CITY OF ALBUQUERQUE

**RE: Nexus Blue
1511 Broadway SE
Grading Plan
Engineer's Stamp Date: 03/29/18
Hydrology File: L14D026**

GRADING AND DRAINAGE PLAN

GRADING PLAN

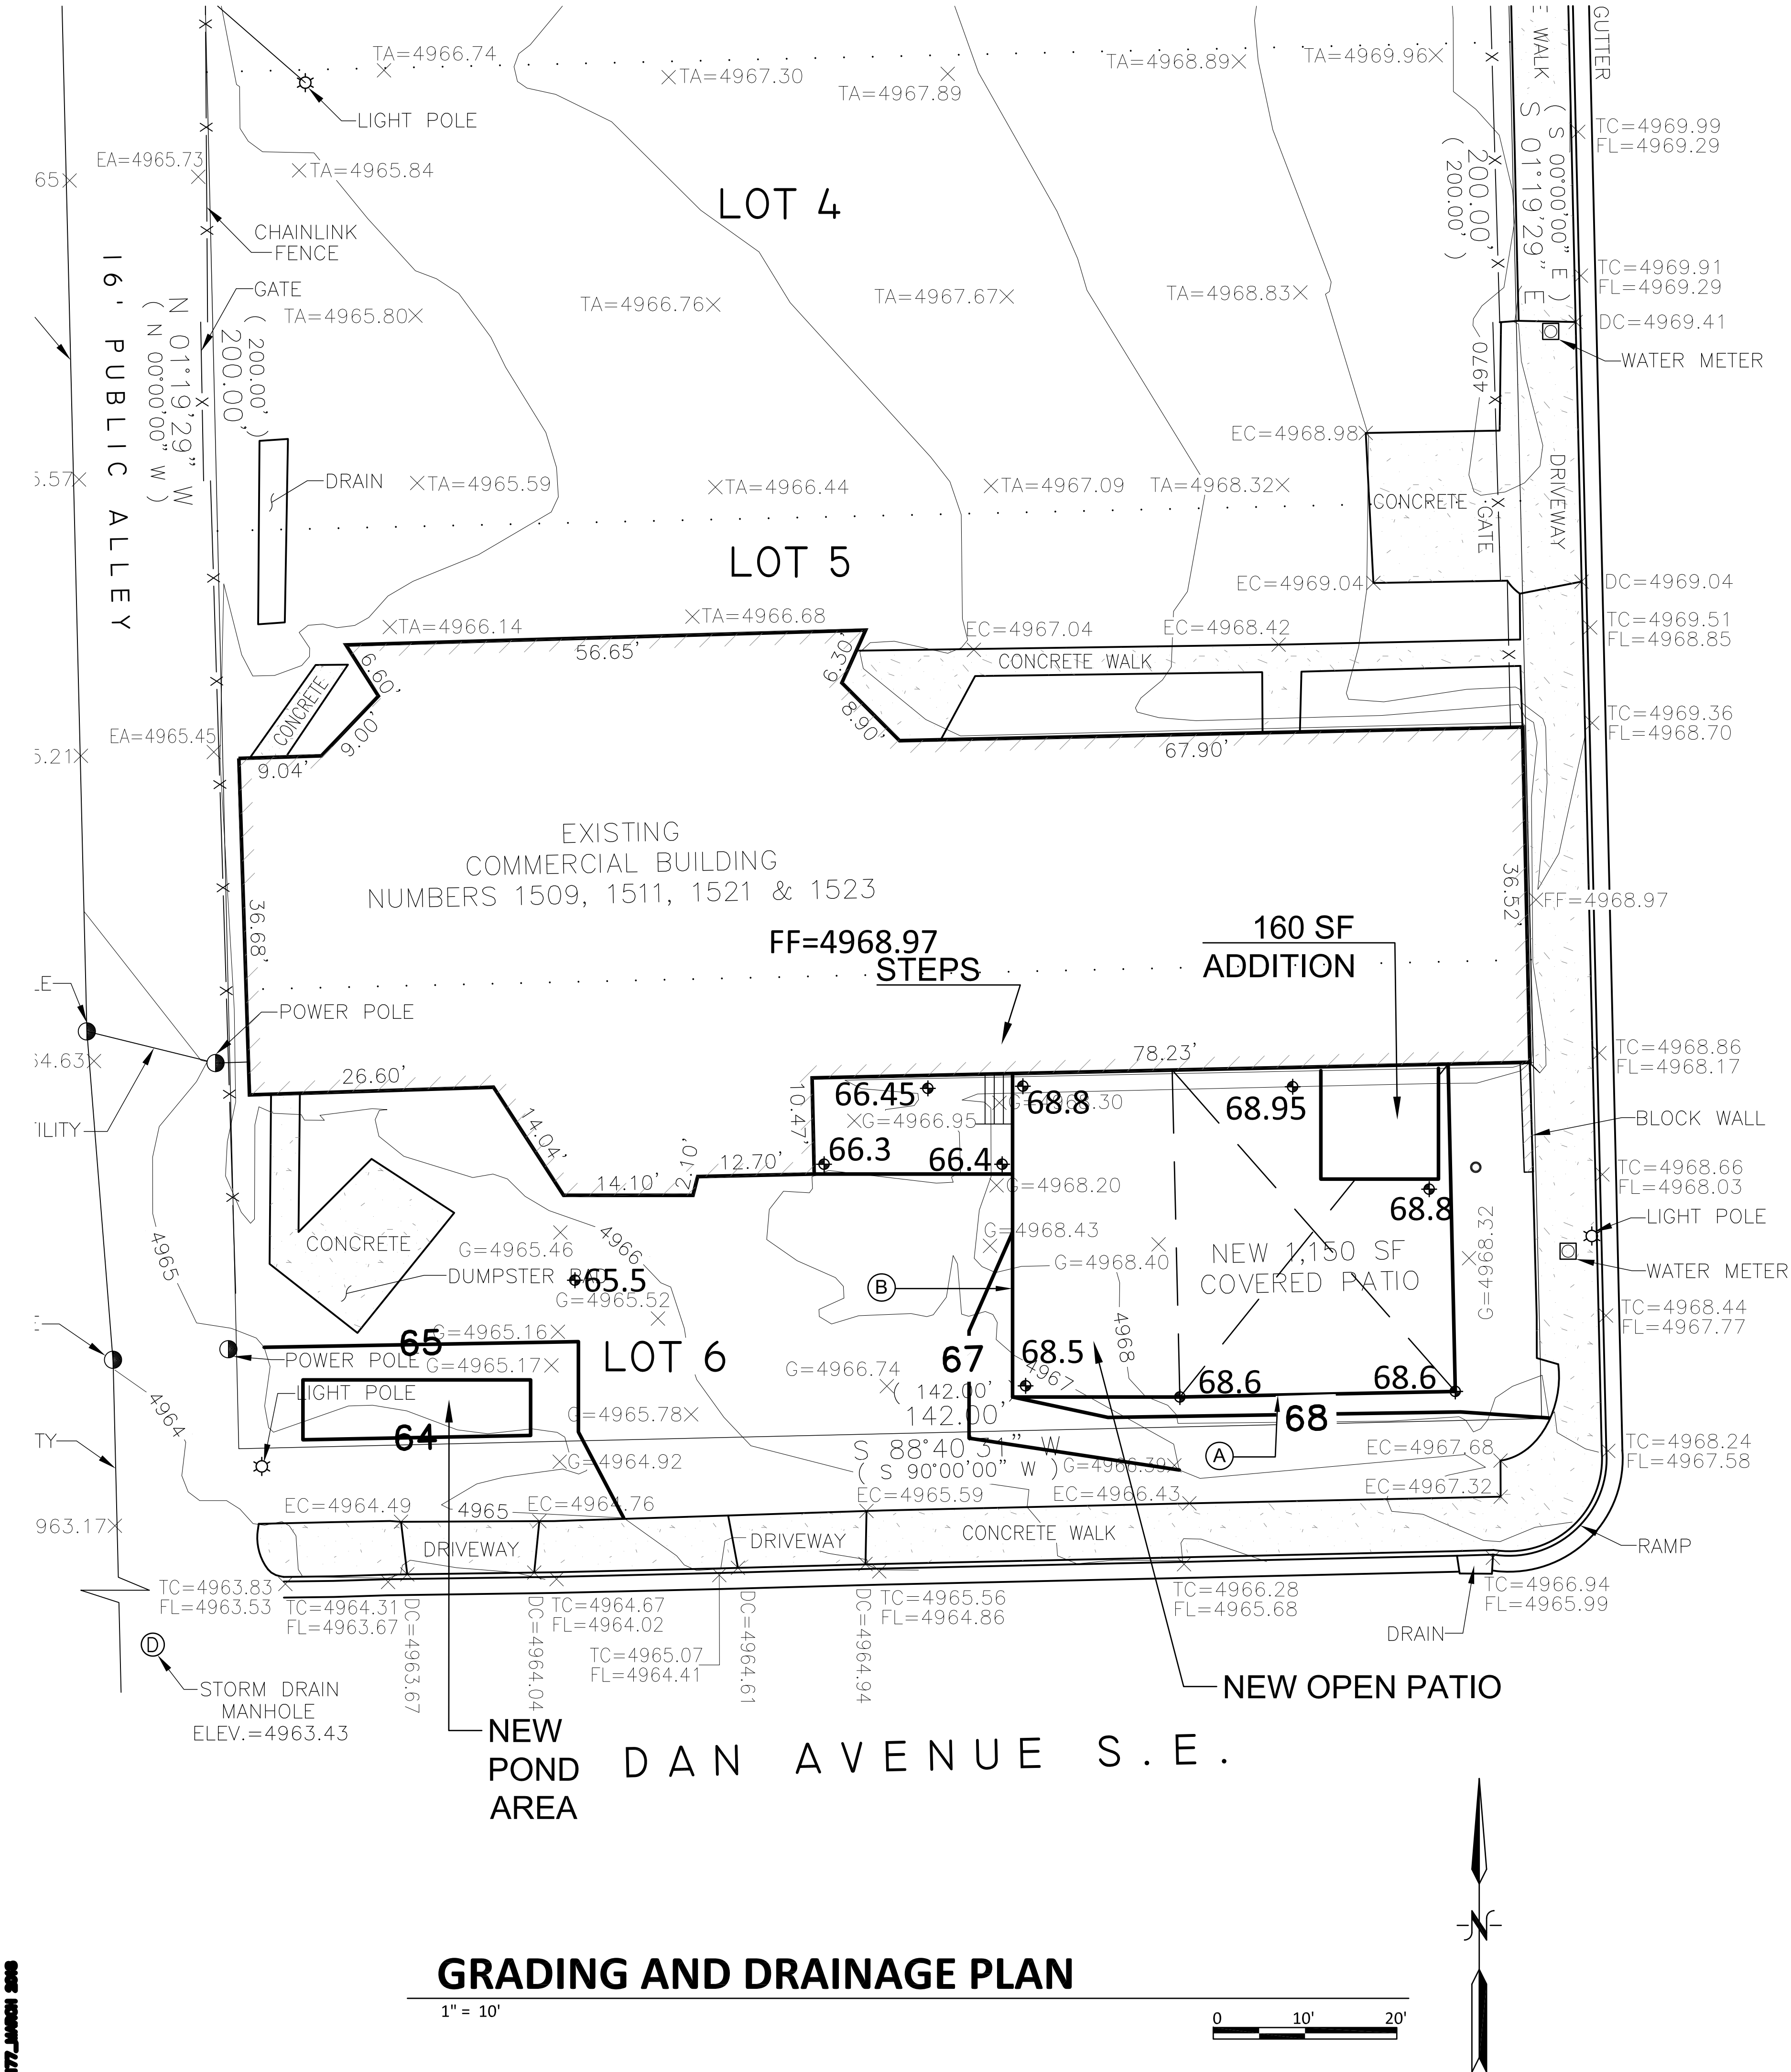
Based upon the information provided in your submittal received 03/30/2018, the Grading Plan is approved for Building Permit.

Please provide a Private Facility Drainage Covenant per Chapter 17 of the DPM for first flush pond prior to Certificate of Occupancy. Please submit this on the 4th floor of Plaza de Sol. A \$25 fee will be required.
